Illinois Tollway Base Sheet Revisions

Section M	Base Sheet Drawings		
	Drawing	Modification Summary	Effective: 03-01-2025
	Roadway Weather Information System (ITS)-Series 1300		
	M-ITS-1300	RWIS Pole, Sensor Mounting Detail

RWIS POLE SENSOR MOUNTING DETAIL

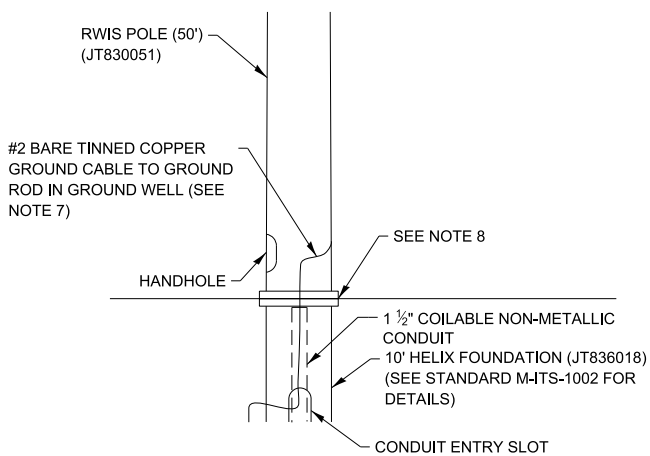
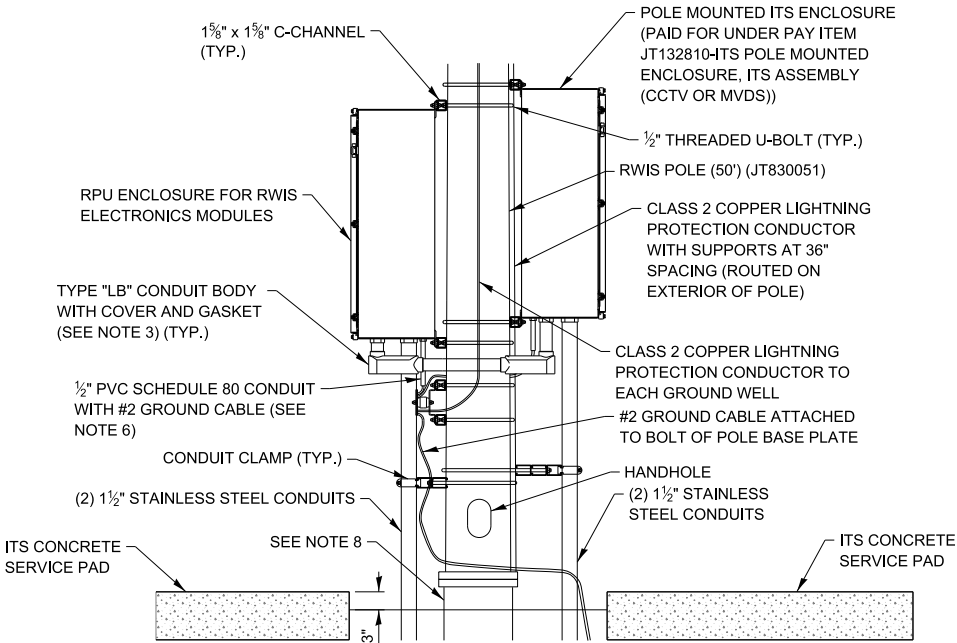
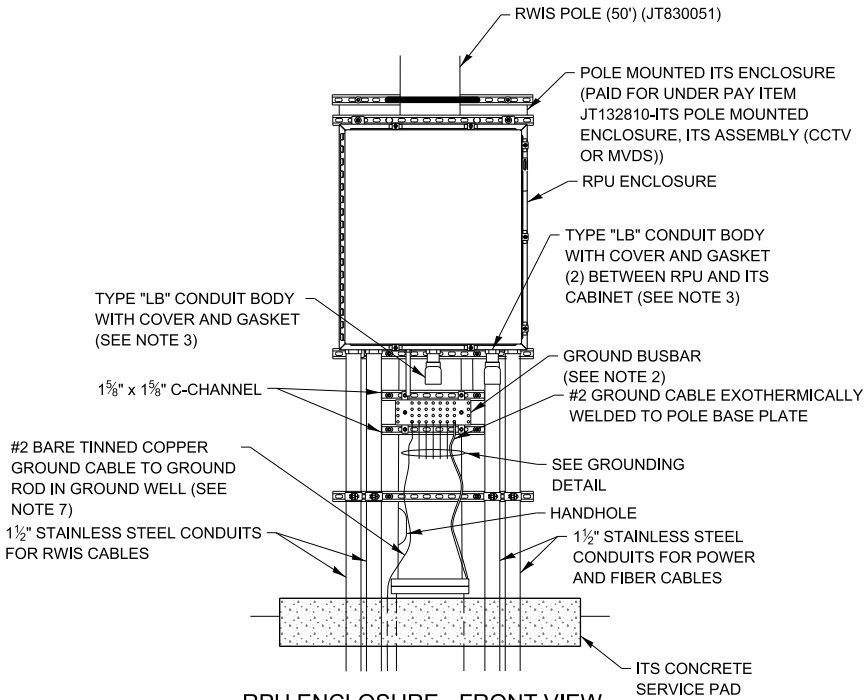
Sheet 1	Revised Note 1:"... excluding CCTV camera and associated ITS component where indicated on the plan sheets..."	
		Revised Note 7 to replace word "placement" by "mounting"	
		Revised Note 9 to add: "... when transitioning to pole exterior"	
		Revised ratio 6:1 to say 1:6

Sheet 2	Revised Note 15 to replace the word "placement" with "mounting"	
	M-ITS-1301	RWIS Cabinet Wiring Diagram	
	Sheet 1	Revised layout of Cisco switch to match the details of Cisco IE-3300-8T2S-E	
		Revised item to call Cisco IE-3300-8T2S-E	
		Revised layout to add access door through the Plexiglas cover to give easy access to IP Relay for proگرامing	
		Revised Cisco license to connect to Cisco IE-3300-8TS2-E

RWIS POLE MOUNTED ITS CABINET WIRING DIAGRAM

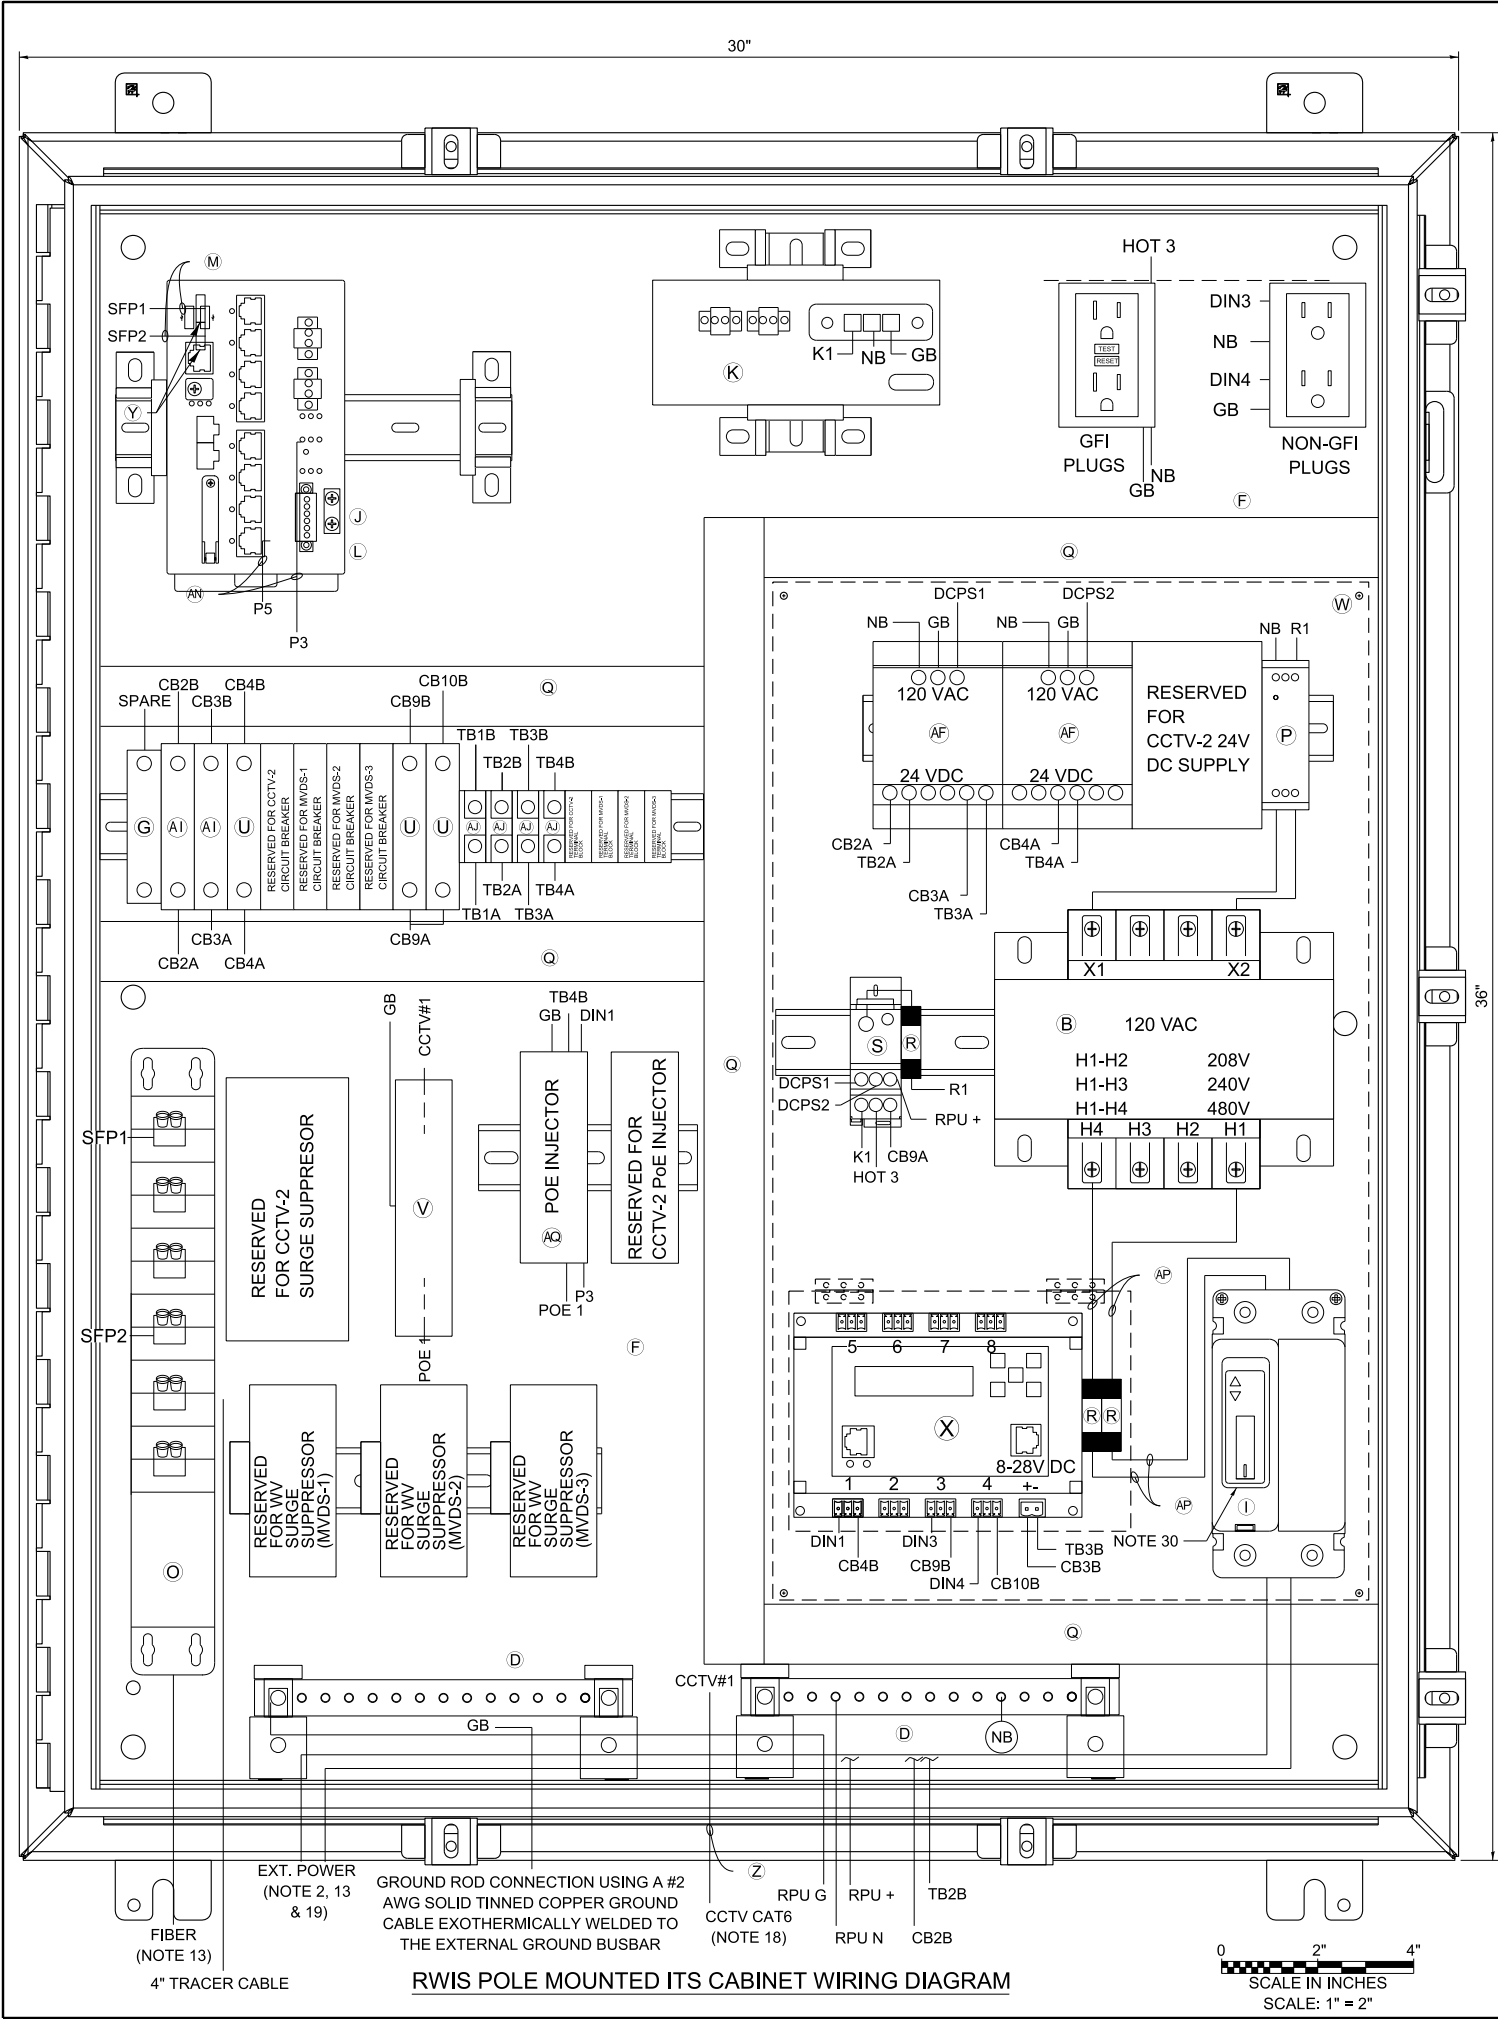
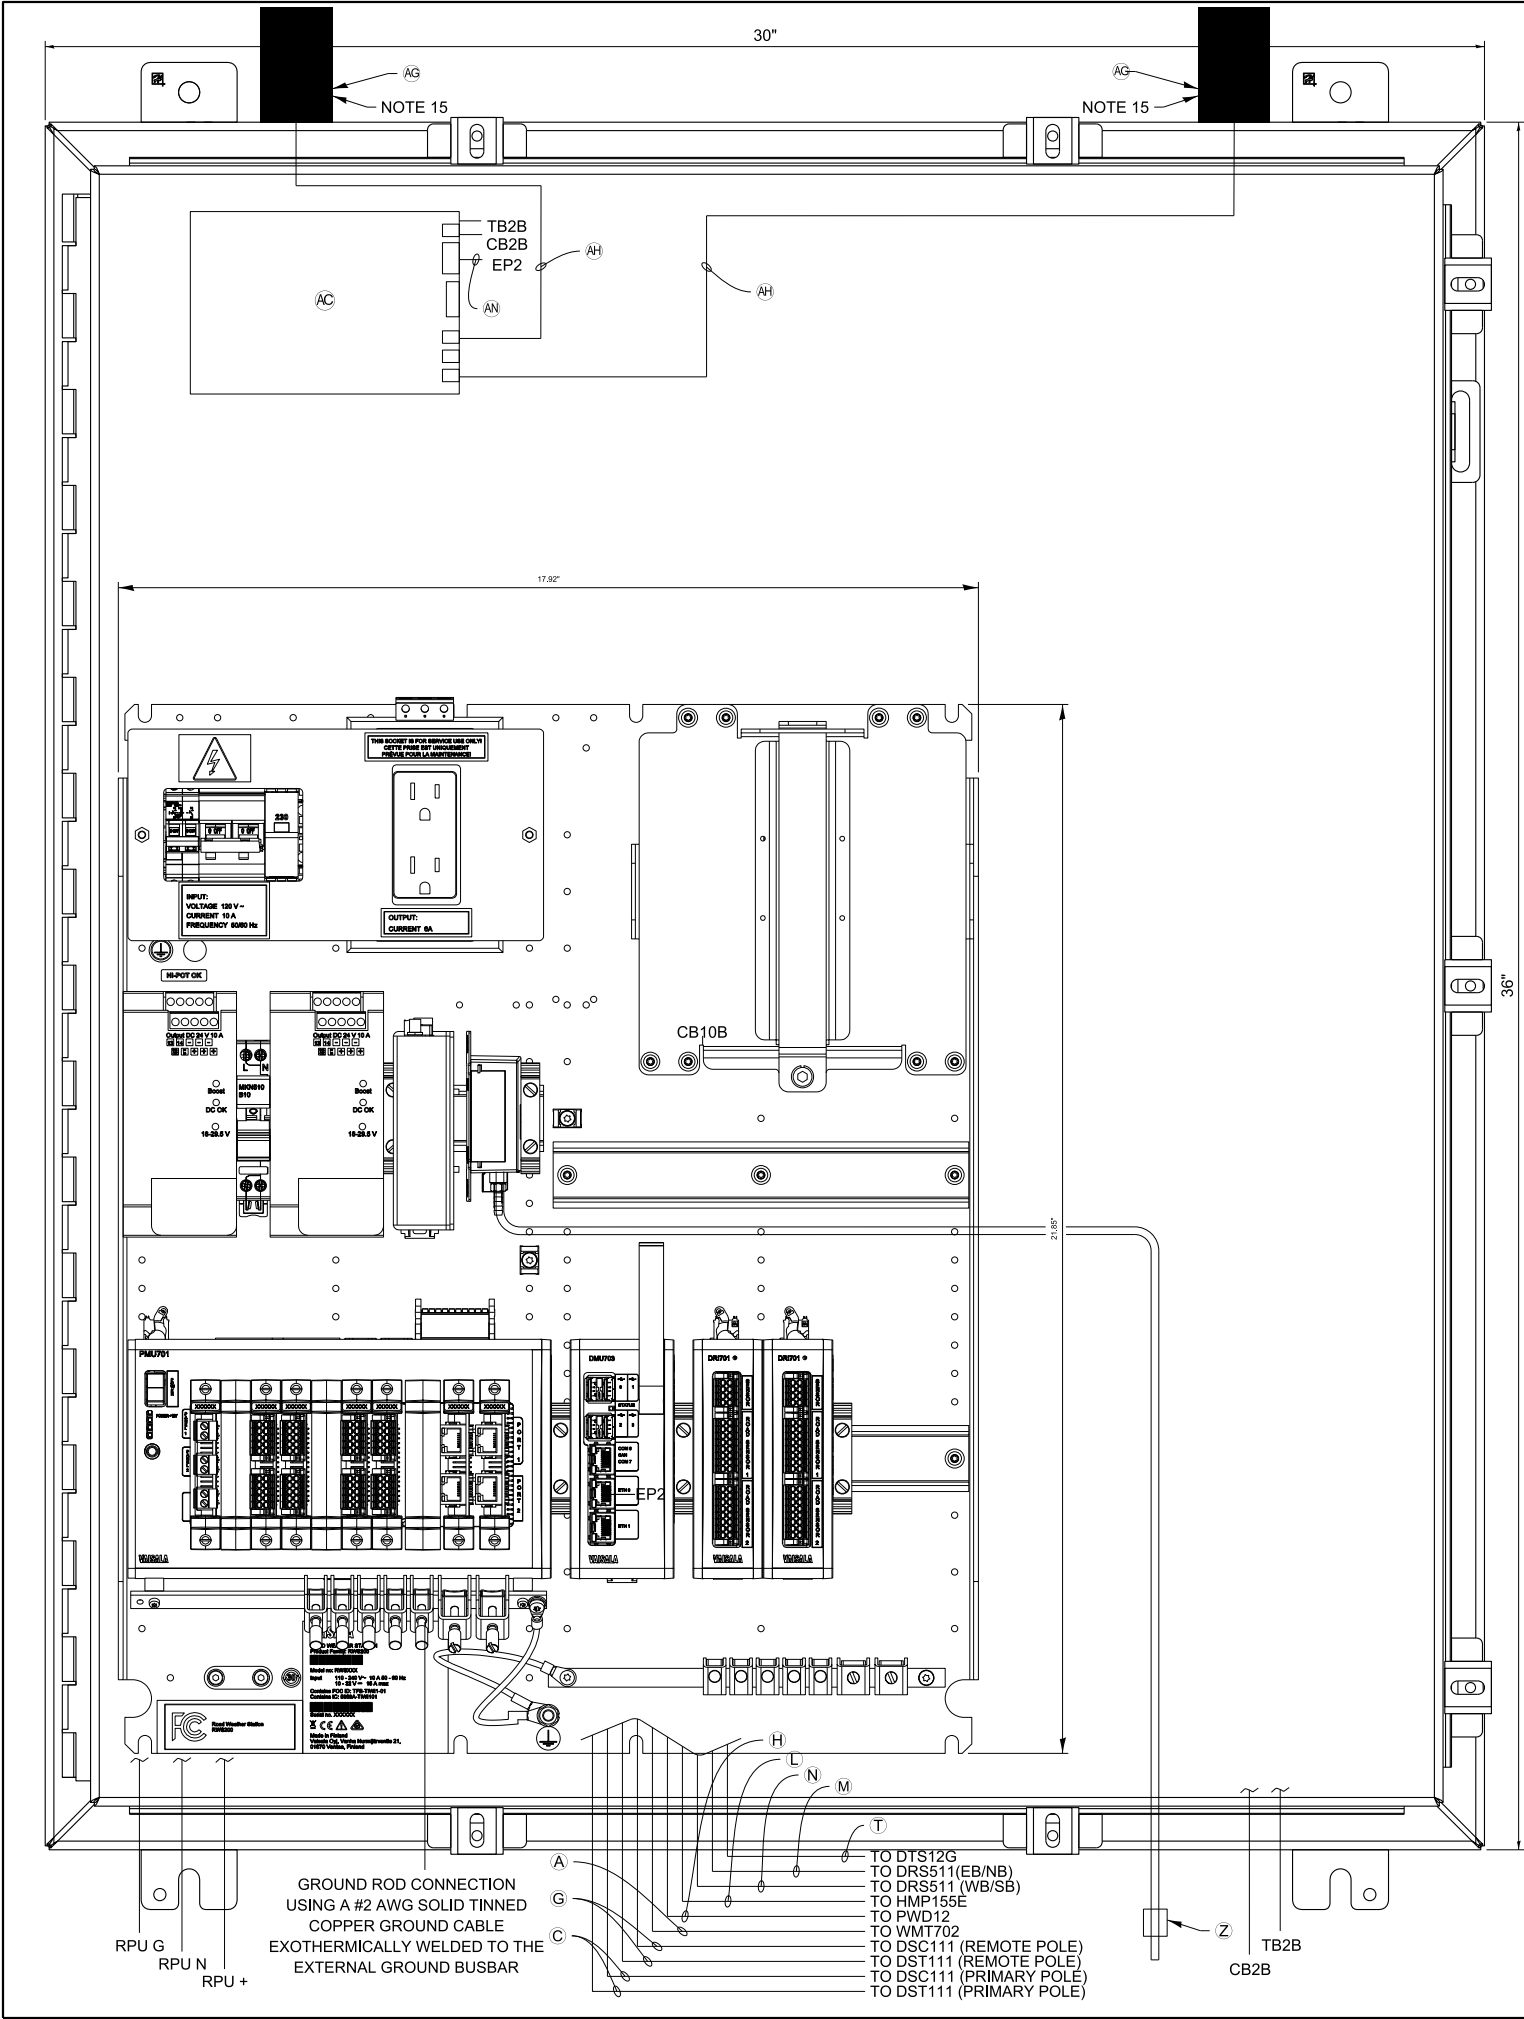
Sheet 2	Revised item DES511 (EB) to say: DRS511 (EB/NB)	
		Revised item DES511 (EB) to say: DRS511 (WB/SB))
